Subject: CC-1218-03/TLC - Greenwood Lakes/Heathrow Interconnection Facilities

ADDENDUM #1

RECLAIMED WATER SYSTEM
REMOTE VALVE MODIFICATIONS

PLAN VIEW

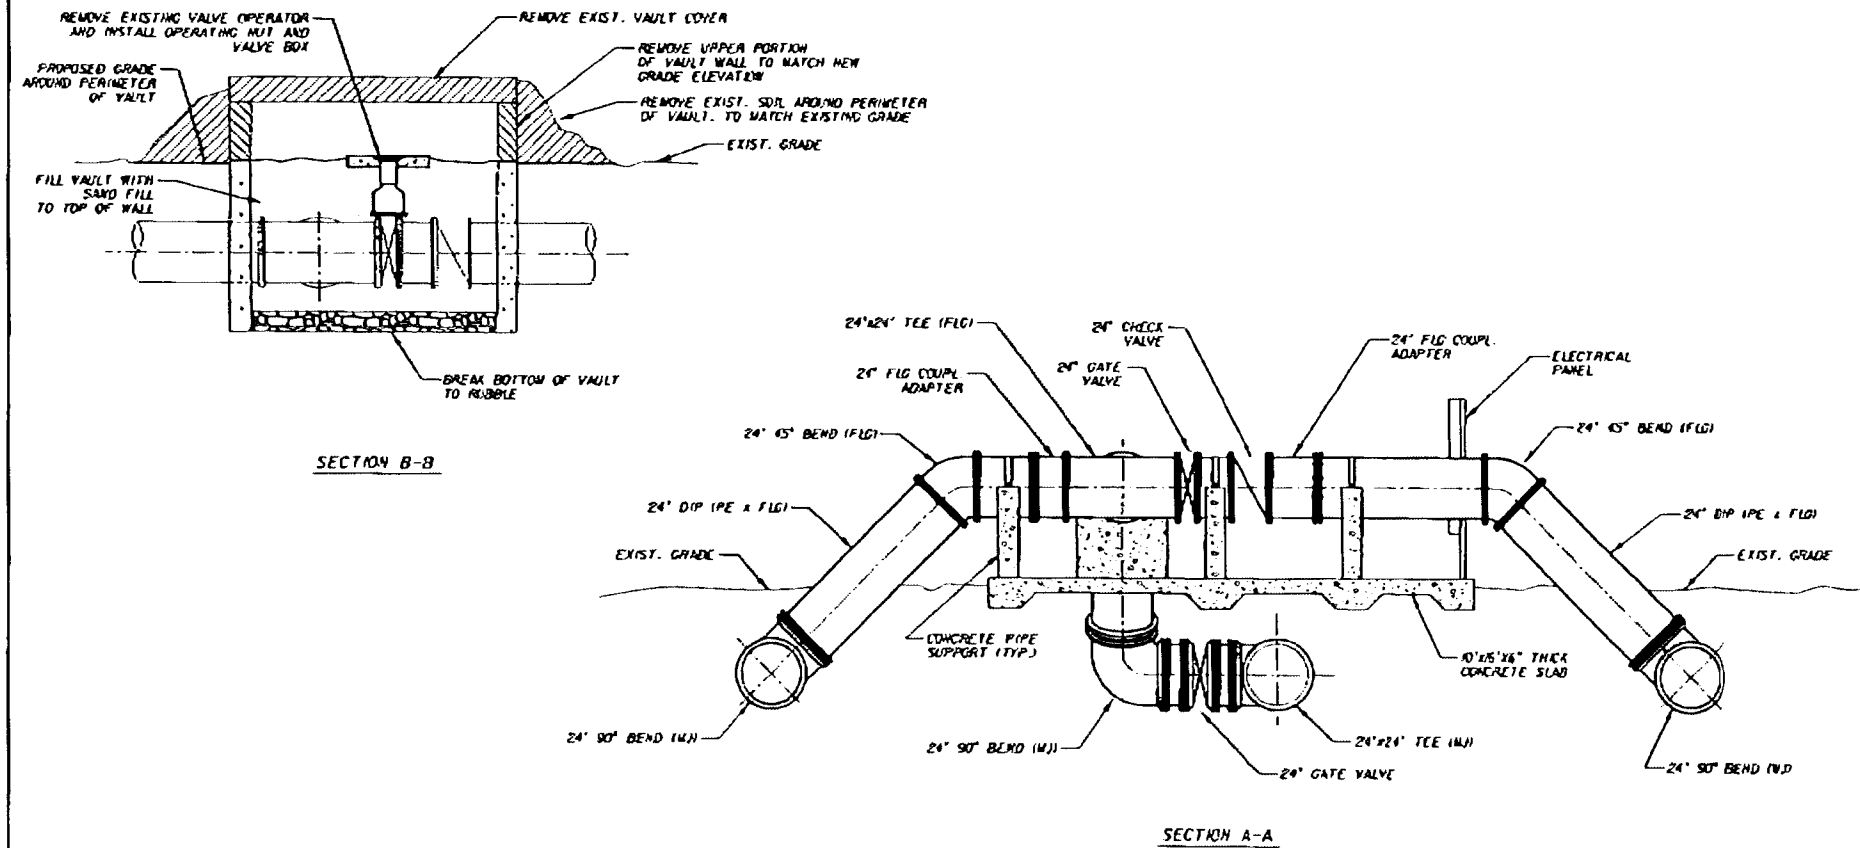
The Greenwood Lakes/Heathrow Interconnection Facilities on-site work shall include the replacement of existing valves per the attached two sheets. Price for additional work shall be hand written as an add-on line item before the total cumulative price. All direct, indirect, incidental costs and labor cost shall be inclusive in the final bid price.
